# **Standards Update Transmittal**

| Reference Number: | 2021-10                                     |
| Standards:        | Improvement Standards, Section(s) 2-17, 4-8 |

Standard Drawings T-21, T-22

## Figure 1 – Fiber Backbone Network

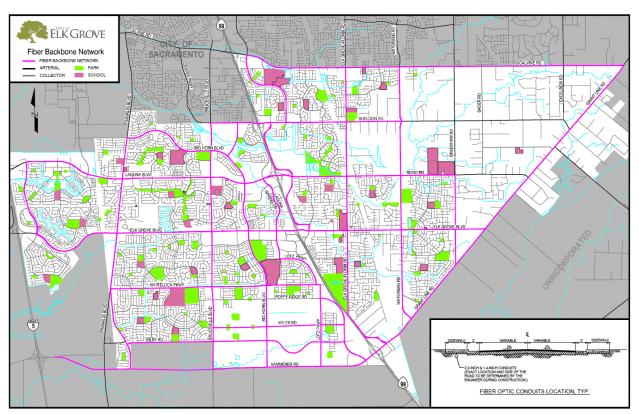
- 1. Improvement Standard:
  - a. Section 2-17," Utilities": add note to reference the standard drawing T-22, "Fiber Backbone Network".

- A. All new sidewalk construction adjacent to roadways shown on Figure 1 – Fiber Backbone Network (below), (also see Standard drawing T-22), shall install a minimum of 2ea 2-inch diameter and 1ea 4-inch diameter plastic ducts for future use by the City. Each conduit shall include a pull-wire and have a Type 6 Pull Box installed at a maximum spacing of 500 feet.
- B. All known existing utilities are to be shown on the plans. In addition, the Consulting Engineer shall submit prints of the preliminary and approved plans to the utility companies involved. This is necessary for the utilities to properly plan their relocation projects and needed additional facilities. Copies of the transmittal letters to the utility companies shall be provided to the City. In addition, the following note shall appear on the first page of the plans:

|          | ATE<br>1/2021 | NOT      | TO SCALE | CITY OF ELK GROVE - PUBLIC WORKS                  | АРРROVED BY:<br>ЭНС |
|----------|---------------|----------|----------|---|---------------------|
|          |               |          |          | TRAFFIC SIGNAL MAST ARM<br>SIGN ASSEMBLY (2 OF 2) | DRAWING NUMBER      |

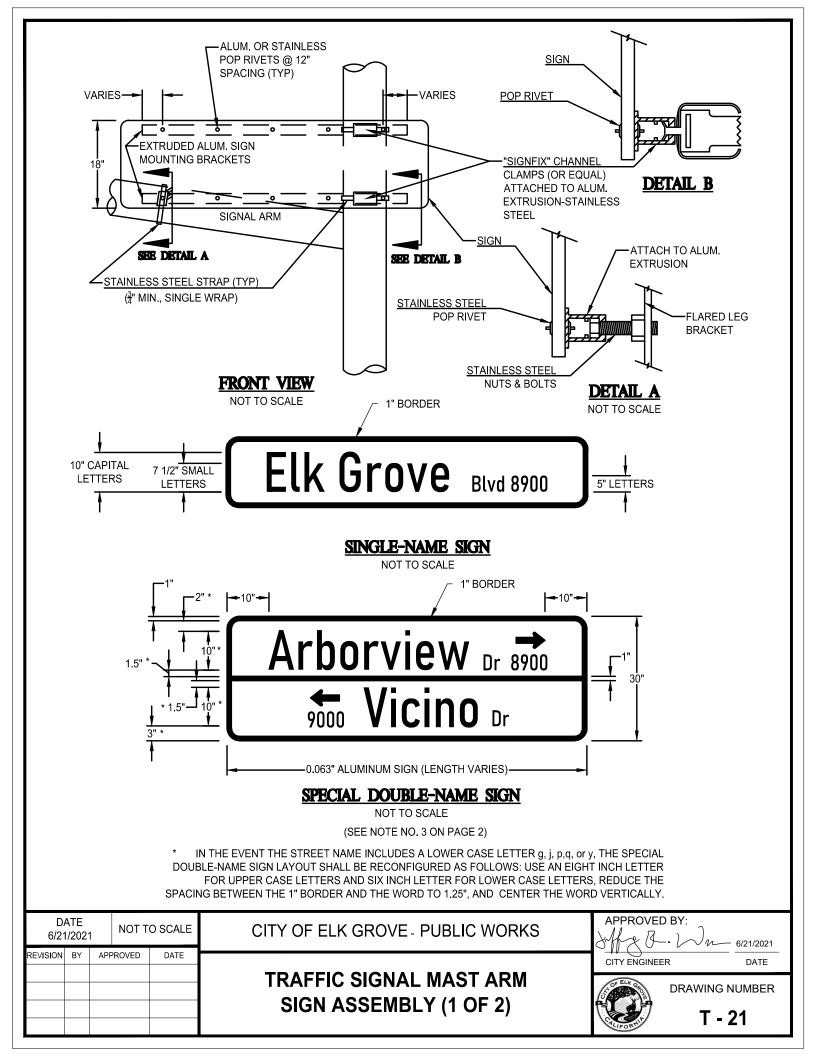
- b. Section 4-8, "Sight Distances and Visibility Easement at Intersections": add Table 1A, Stopping Sight Distance.
- 2. Construction Specifications:
  - a. Section 48-3, "Placement": revise striping waiting period to 7 days after completing the final lift of asphalt concrete.
- 3. Standard Drawings:
  - a. T-21 TRAFFIC SIGNAL MAST ARM SIGN ASSEMBLY (1 of 2): create a new standard drawing for the traffic signal mast arm sign assembly.
  - b. T-22 FIBER BACKBONE NETWORK: create a new standard drawing for the fiber backbone network.
